Re: Restoration Bay

Case Number: Z/LU-14-09-19 Parcel: 33-30-15-00000-240-0100

RFAI Response #1

T A - MULTI PURPOSE TR
EXHIBIT

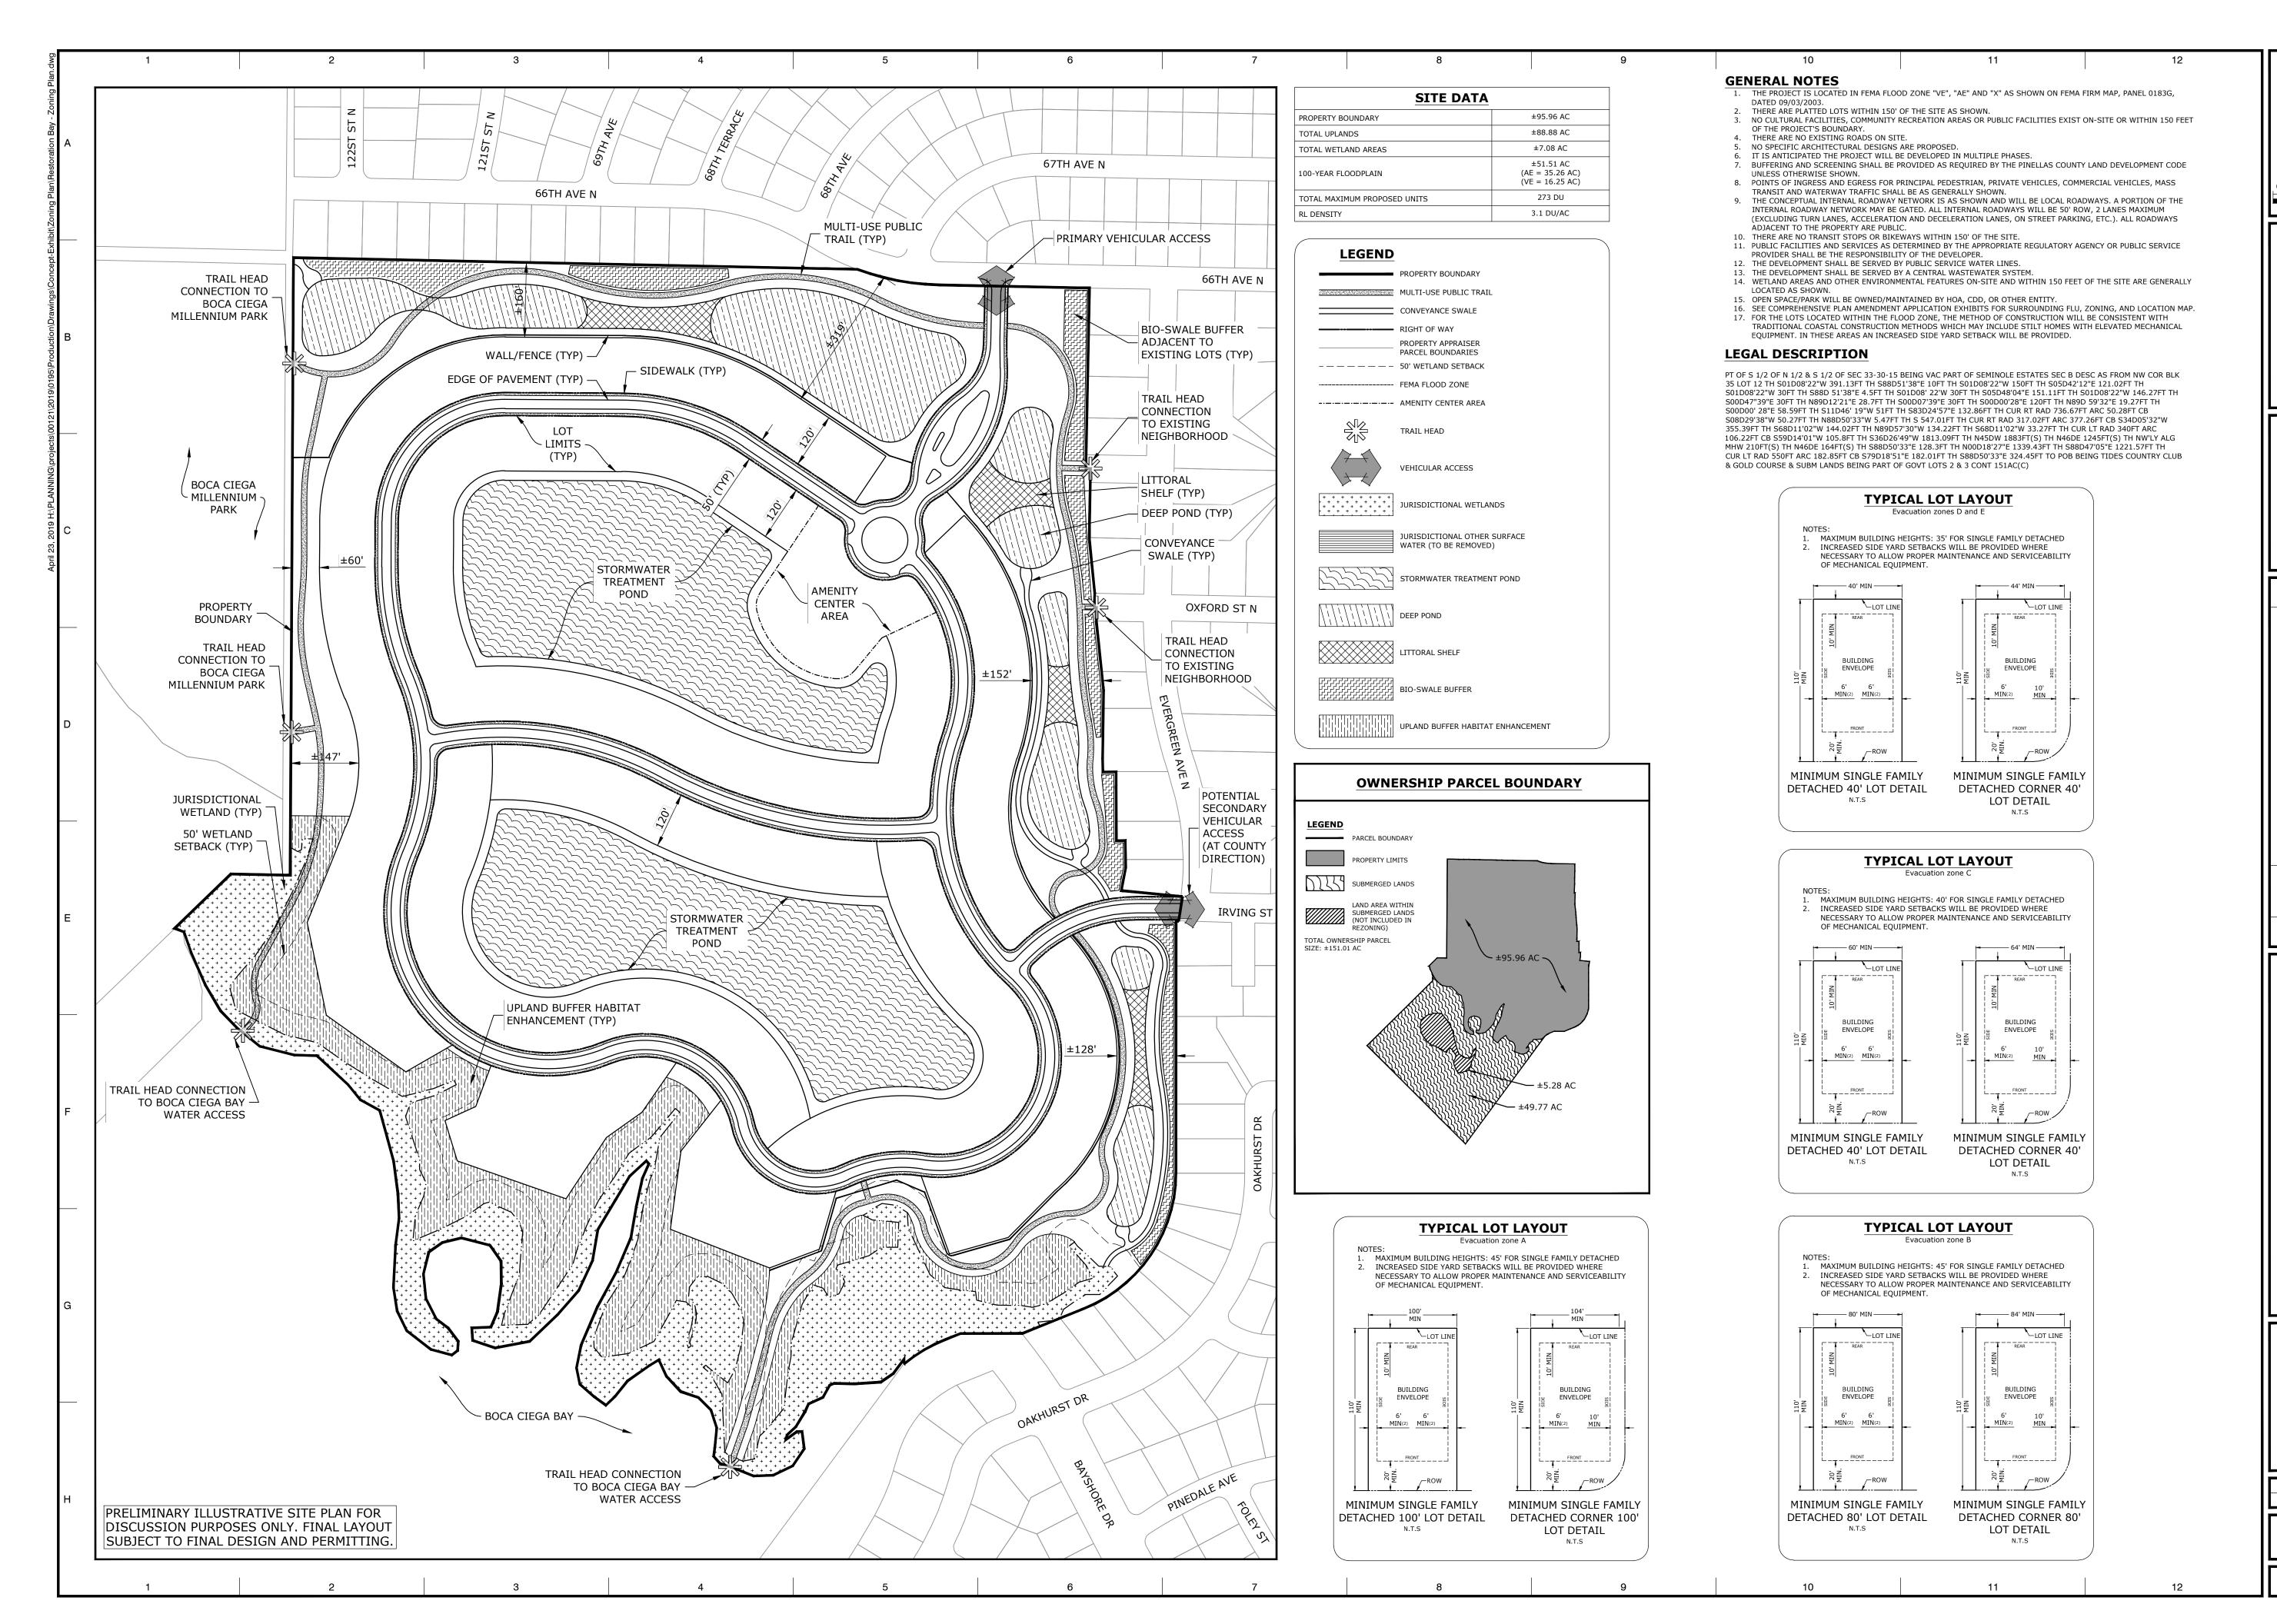
4. Staff Comment: While projected roadway intersection levels of service are satisfactory, the proposed density of the project may alter the roadway classification of 66th Avenue North and creates traffic management conflicts that have not been mitigated by the applicant. The application does not consider unmet area needs of other multimodal improvements in the area (incomplete sidewalk gaps, trail connections) as required by the Transportation Element of the Comprehensive Plan when considering decisions on Future Land Use Map amendments.

With respect to the last comment re: other multimodal needs in the area, it should be noted that the proposed plan does satisfy previously unmet needs by providing a public access multi-use path around the entire development that connects not only the surrounding neighborhoods to both the County park and the waterfront (which was not possible with the prior golf course use), but also connects the county's neighboring Boca Ciega Bay Millennial Park to the waterfront. This certainly does provide a previously unmet need as the public will have access to the trail and the waterfront. The Applicant also has offered to implement practical and feasible streetscape, sidewalk and safer pedestrian access features along _______, to which staff previously had agreed as an appropriate mitigation strategy. If staff will identify other specific mitigation measures which are the result of the project's impacts (as opposed to other pre-existing failures/issues), then the Applicant certainly will mitigate them as required by law.
